Technical Note

Integration of Photometer PFM BDAs: alignment
issues

Ref: SPIRE-RAL-NOT-
002344

Figure 1 (excerpt from ICD dwg 10209721, with coordinate axes shown)

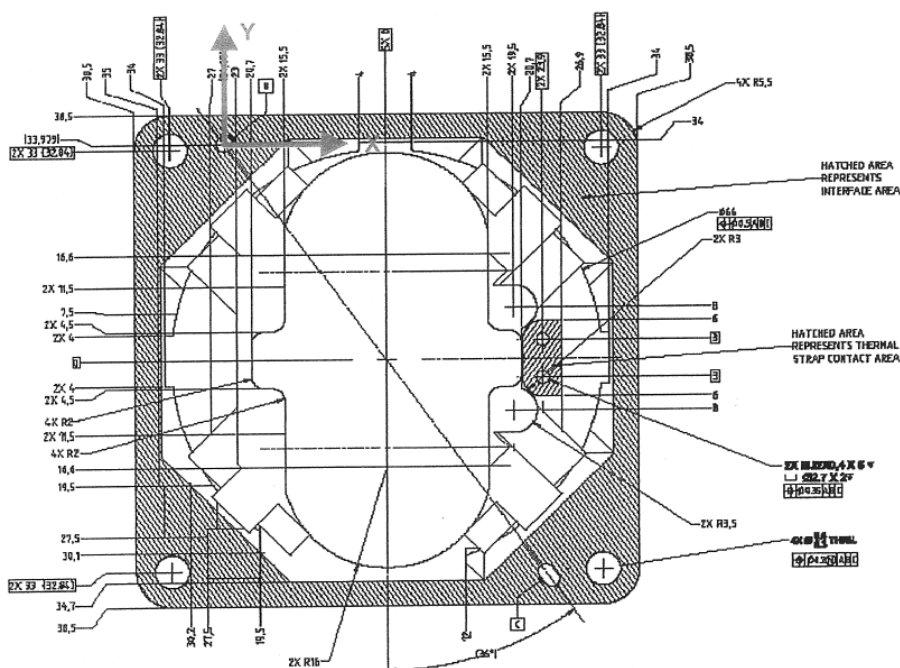
From RD1, the local coordinates system is reproduced below (originally from ICD). The local z axis is out-of-the plane of the figure.

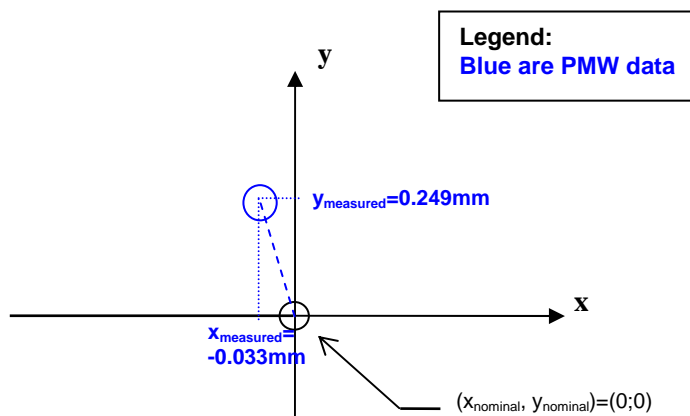
The lateral in-plane shift of the BDA centre wrt to nominal centre is found to be (total i.e. ambient and cold measurement):

- along X: -0.033 ± 0.05 mm
- along Y: $+0.249 \pm 0.05$ mm

so that the max displacement from centre is $\sqrt{dx^2+dy^2} \sim 0.251 \pm 0.100\text{mm}$. This represents $\sim 8\%$ of the PMW pixel size and, at the entrance focal plane (CFIL1 location), is equivalent to $0.436 \pm 0.175\text{mm}$ displacement which is within the oversize (wrt FoV) of the shaped aperture at CFIL1. Nevertheless this means that the centre of the PMW FoV is shifted on sky by $\sim 3.16 \pm 1.26\text{arcsec}$ wrt the nominal location in the Herschel coordinates system but this does not affect directly the performances of the SLW channel.

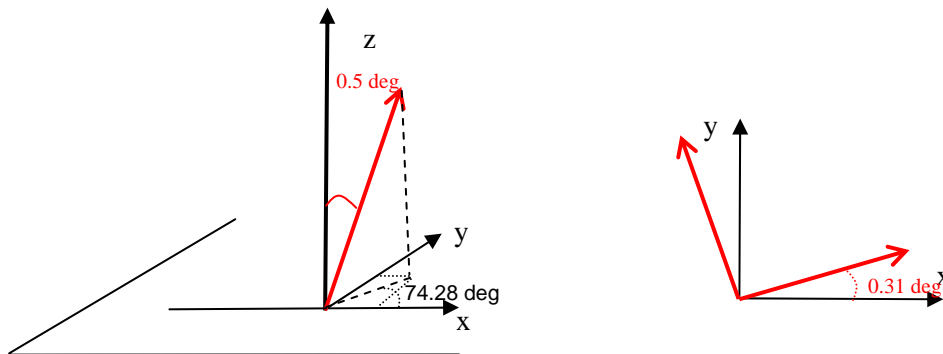
The measured tilt of the as-built x-y plane compared to the nominal one is found at ambient to be 0.5deg wrt the local z axis. Although this measurement is at ambient only, this is at the limit of the $\pm 30\text{arcmin} = \pm 0.5\text{deg}$ acceptable tolerance around the gut ray which nominally is aligned with the local z axis at the centre of the array. The cryo data indicates supplementary hysteretic effect (in rotation about x) which is equivalent to uncertainty in the range of $\pm 0.025\text{deg}$ on the above value.

This tilt wrt z axis will reduce the coupling from science beam into BDA PMW feedhorns. First-order estimate indicate that $\sim 1\%$ loss in coupling efficiency could be resulting from such a tilt.

A correction is still desirable and experience with SSW BDA shows the possibility of having a wedge shape interface plate to correct even smaller amount of tilt deg in the case of SSW).

Likely need for correction by 0.5deg of the PMW BDA tilt wrt z axis via wedge in interface plate (as per SSW). Extra correction of the in-plane rotation is dependent on the PSW value.
